RIDEM Submission

Fieldstone Farms

South Kingstown, Rhode Island

DEPARTMENT OF ENVIRONMENTAL MANAGEMENT
OFFICE OF WATER RESOURCES
FRESHWATER WETLANDS PROGRAM
APPROVED WITH CONDITIONS
AS SPECIFIED IN THE LETTER OF APPROVAL
DATED APR 19 2013 FILE # 13-0034
NO CHANGES ALLOWED WITHOUT PRIOR APPROVAL
APPROVED PLANS MUST BE AT CONSTRUCTION SITE

Grading Plan - 3
Fieldstone Farms
 Assessor's Plat 16-4, Lot 9
 South Kingstown, Rhode Island
 Prepared for
Old North Land Investments LLC
 75 Lambert Lind Highway
 Warwick, Rhode Island 02886
 DE Job No: 1062-168 Copyright 2013 by Diprete Engineering Associates, Inc.

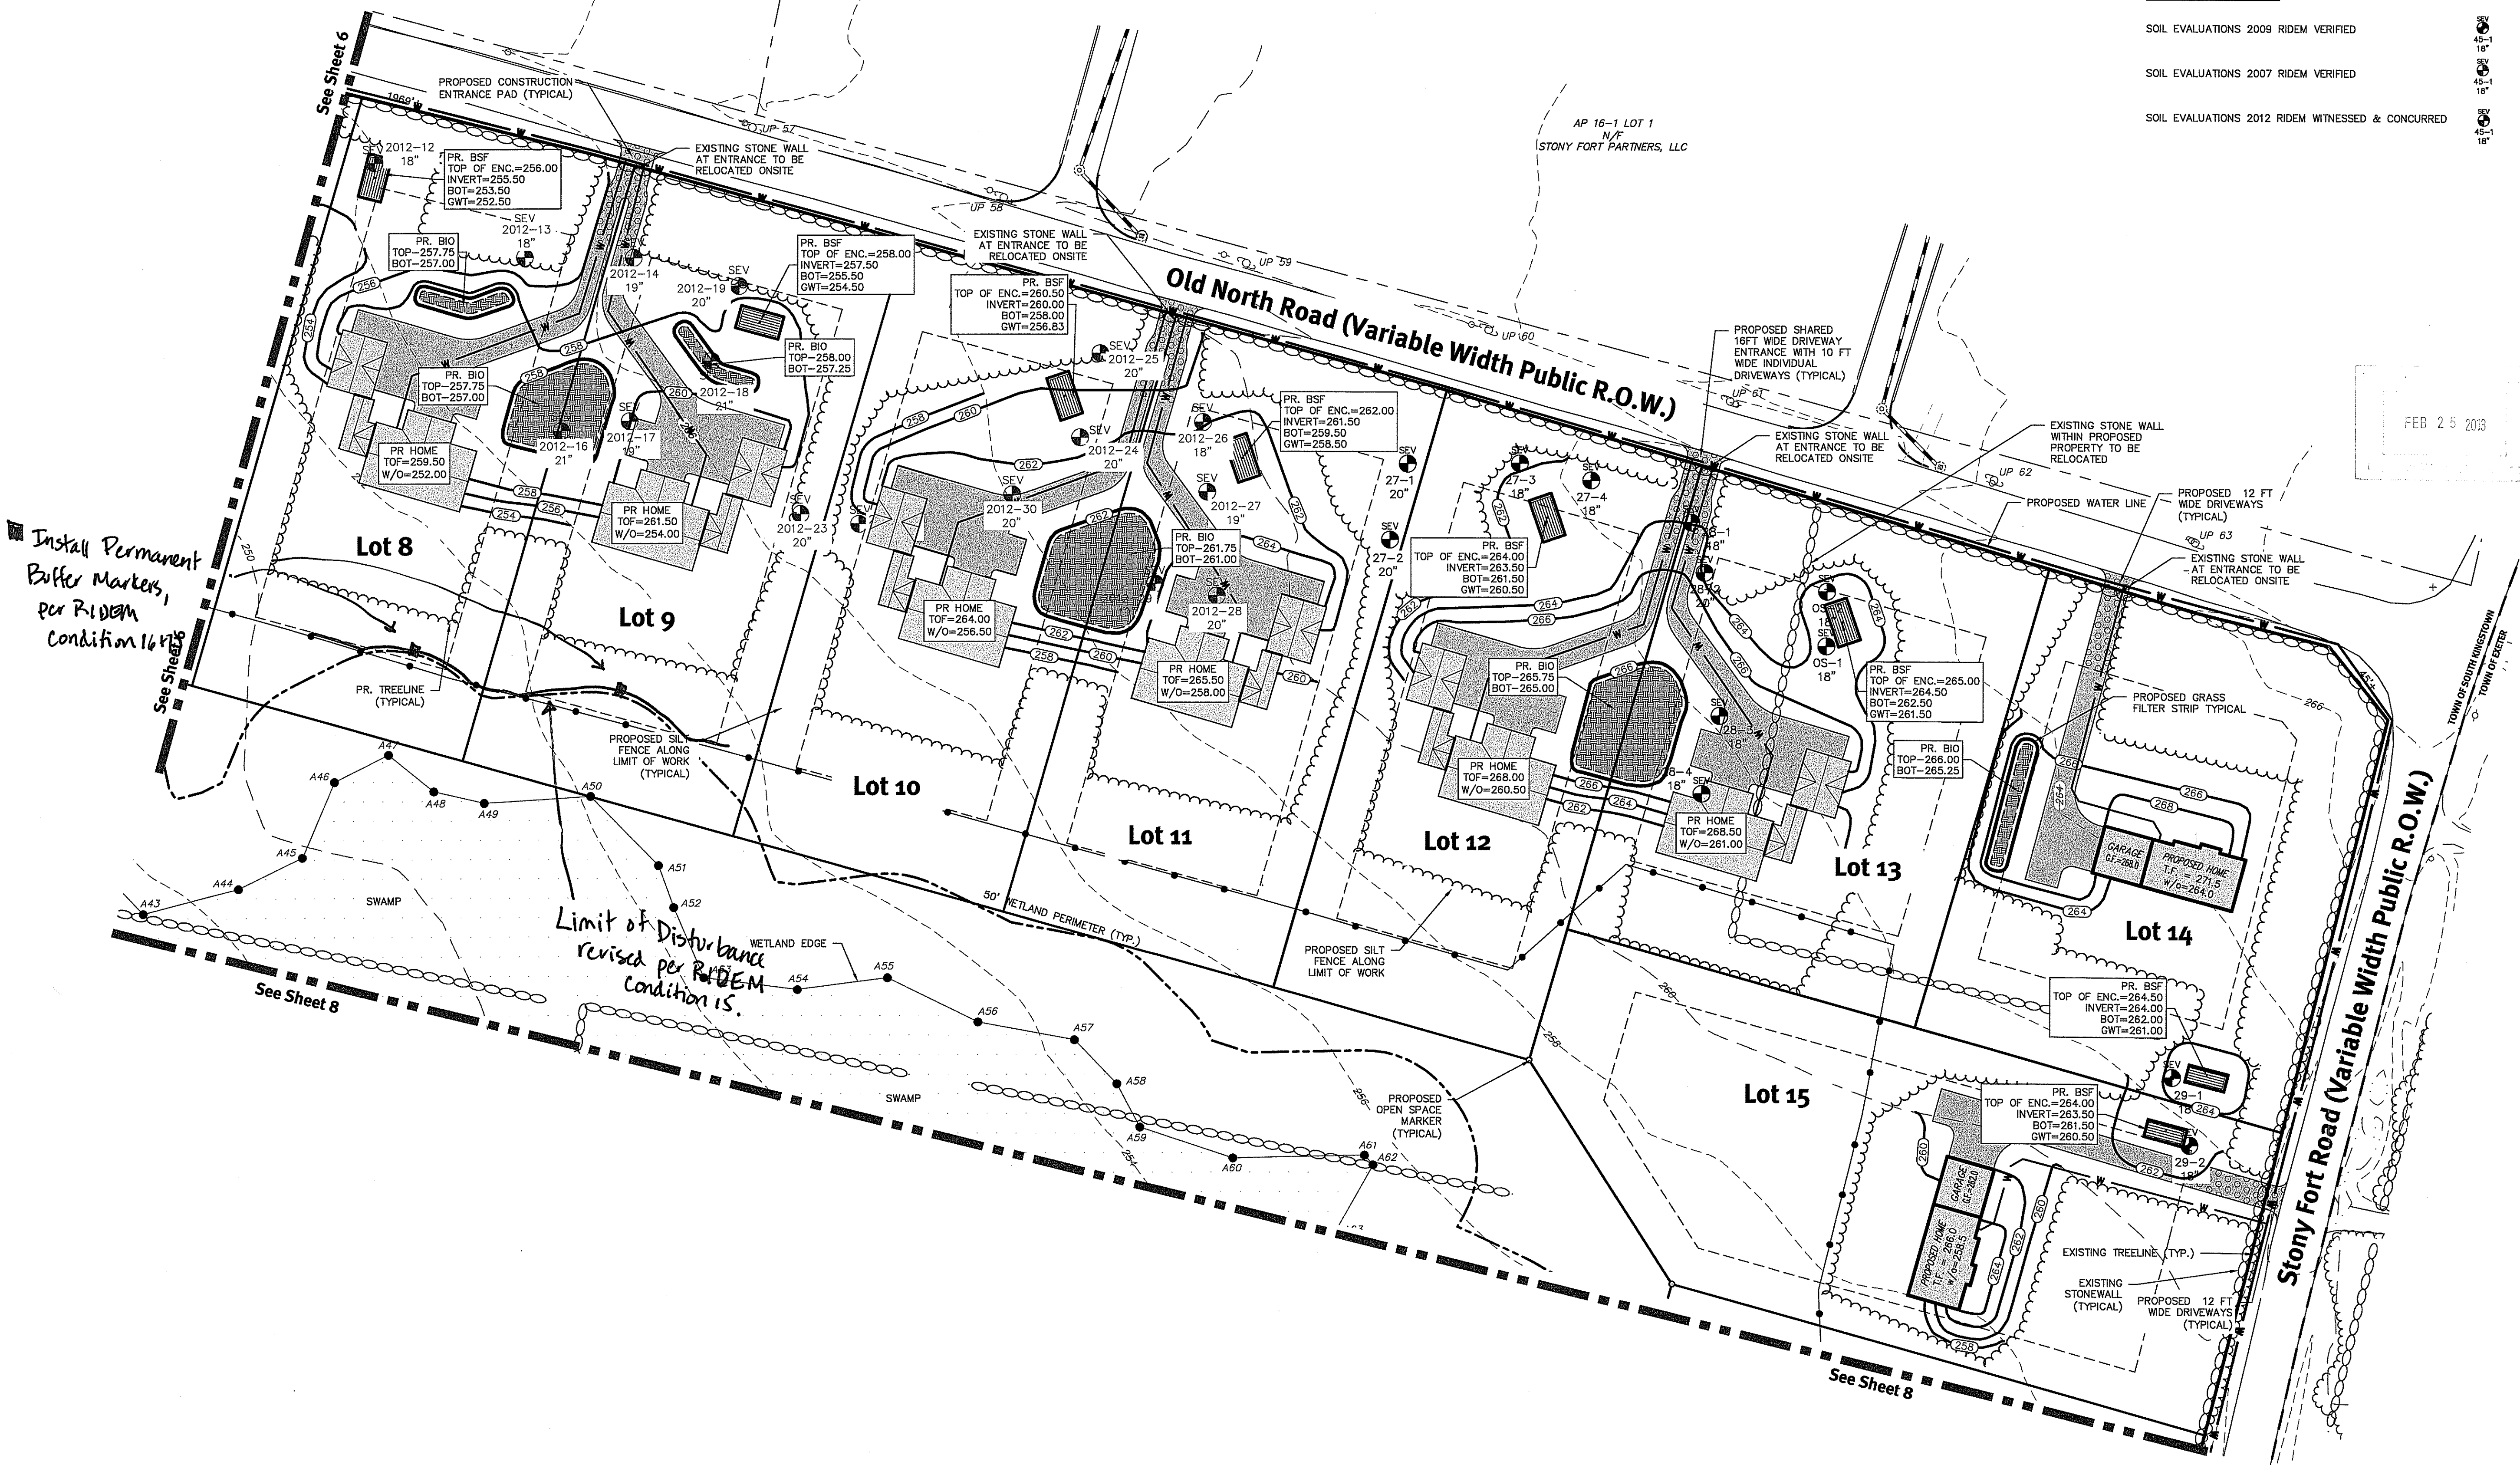
Install Permanent Buffer Markers, per RIDEM Condition 16

Limit of Disturbance revised per RIDEM Condition 15.
